Caltrans District 12

SOCTIIP Collaborative Meeting
March 24, 2008

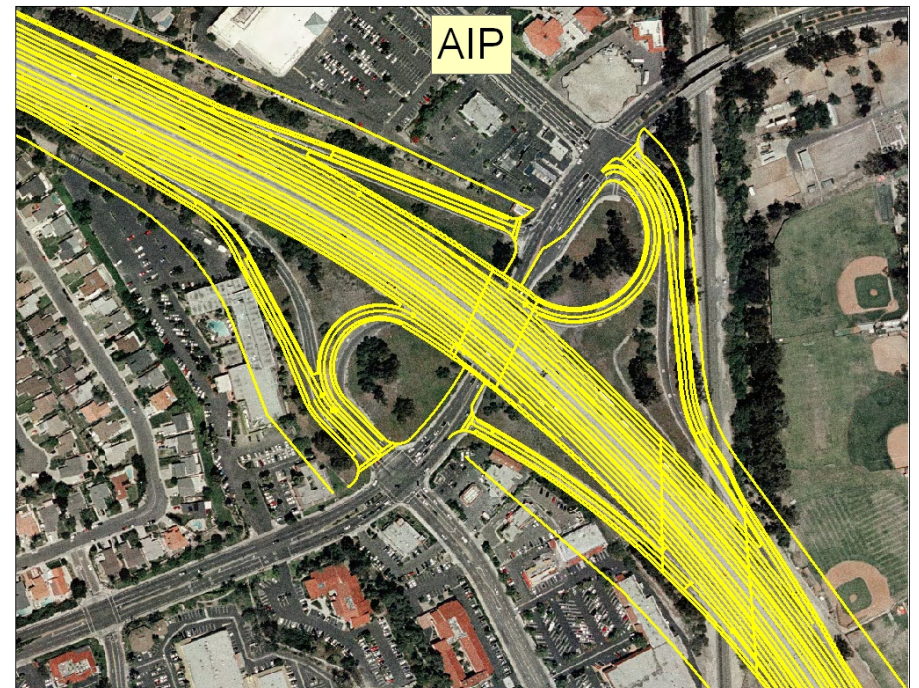
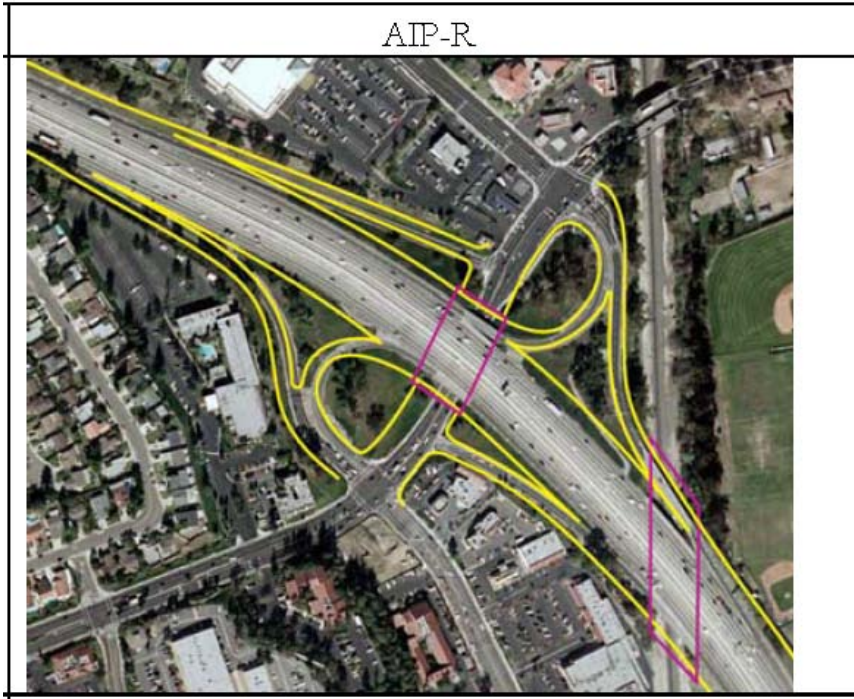
- SMI asserts “In the end, however, non-standard-yet safe-features are often approved...” The SMI report is drawing the conclusion that any or all of the non-standard features would be safe before the project is even built.
- What the SMI report is missing is that some of the highway facilities could be designed to fully meet the HDM standards but still does not meet the operational requirements for a given location.
- An example of this situation is a ramp geometric design that might be standard but the overall ramp body lacking the storage capacity to handle the traffic demand. This ramp would experience delay and more accidents and will be rendered as it is operationally deficient.

Crown Valley Parkway

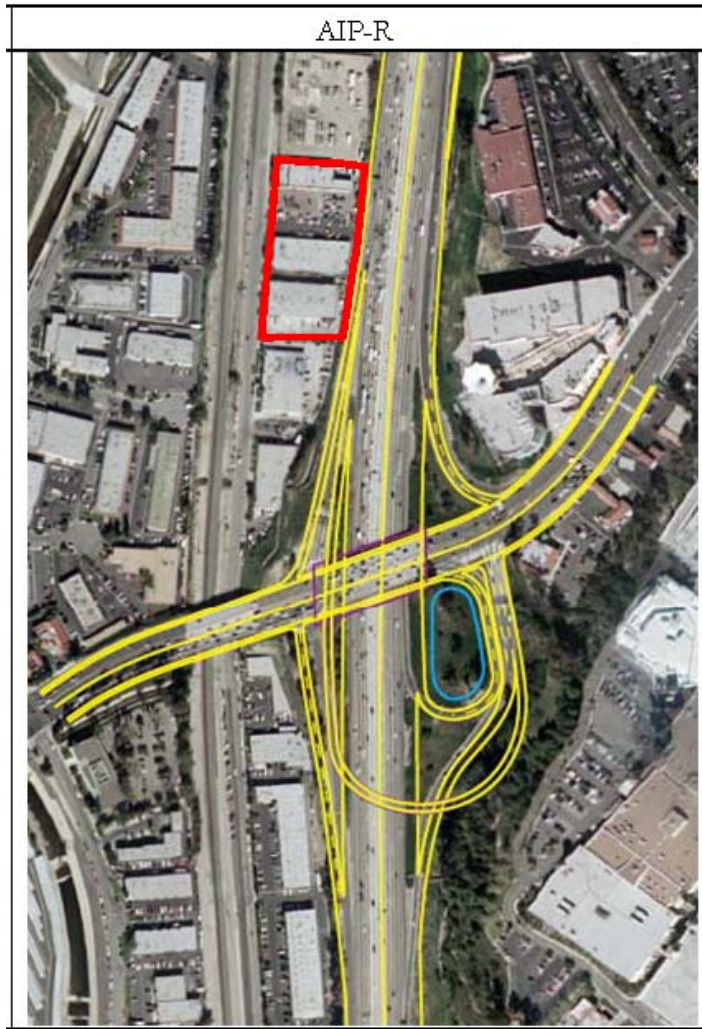
1. Geometric Alignment Concerns S/B Ramp:
 - The required distance between successive off ramps is not accurate;
 - There is not sufficient horizontal or vertical clearance between CVP and I-5 without realignment of vertical profile of CVP, which would create impacts on other ramp terminals.
 - Safety concern as a potential blind horizontal curve follows a steep crest vertical curve.
 - The length of the ramp may not be long enough to achieve all the safety requirements.
2. Would have massive structures that historically Orange County communities have been sensitive about.
3. Noise and visual Impacts
4. Access Control Issues-additional right of way impacts

Figure 10: Ortega Parkway Interchange AIP-SEIR

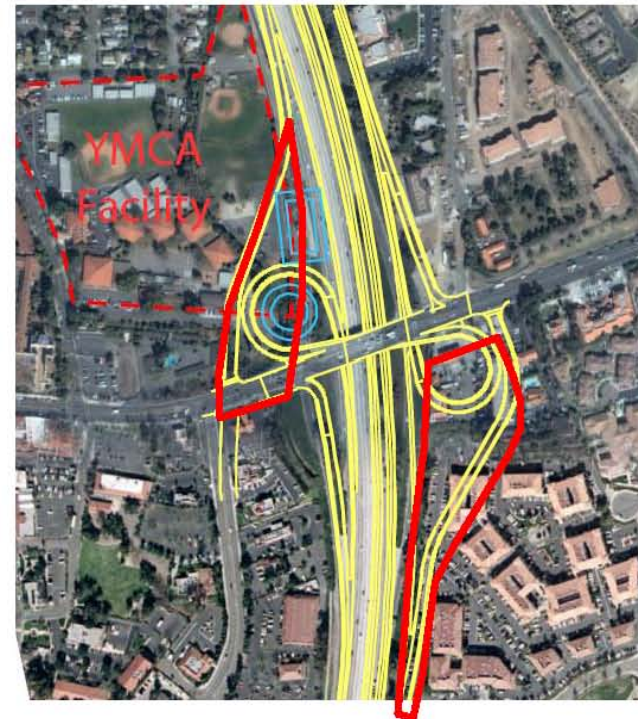
Instead of the smaller footprint alternatives shown above, the AIP-SEIR proposes a large partial cloverleaf design for this interchange, shown in Figure 10 to the right. This is a highly inappropriate for this location, and results in massive impacts to private properties and community recreational resources. In fact, the SEIR states that the concept shown at right was considered by the City, but was not selected for further development. Therefore, the AIP-SEIR proposal for this interchange is inconsistent with local plans.
